RE: Response to Comments, Bennoc Area NPDES OIL00159 Application for American Energy Corporation in Belmont County, Ohio

Response to OEPA Comments from Bruce Goff and Eric Nygaard
Dated 8/21/12, 8/15/12, 7/20/12, 7/13/12, and 7/11/12
Bennoc NPDES Permit Application
OIL00159

Hydro-Chemical Analysis of Waste Water Discharge and Anti-Degradation Assessment: American Energy Corporation's Bennoc Coarse Coal Refuse Area Ponds 001 and 002

Wheel treatment system – pictures provided by www.chemstream.com

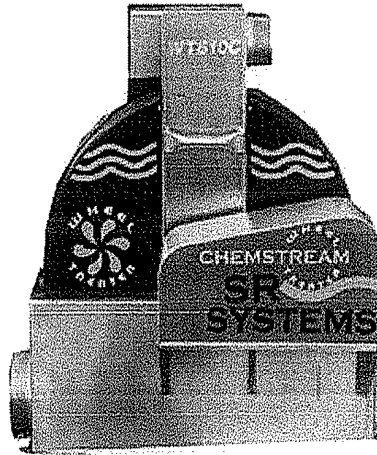
Comment: Do you happen to have any photos of the treatment ponds, the outlet structures, the chemical feed equipment and the discharge drainage ways (outlet ditches) you can share?

Response: We do not have any pictures of the proposed treatment ponds and their structures. However, we do have a picture (below) of the proposed wheel treatment system.
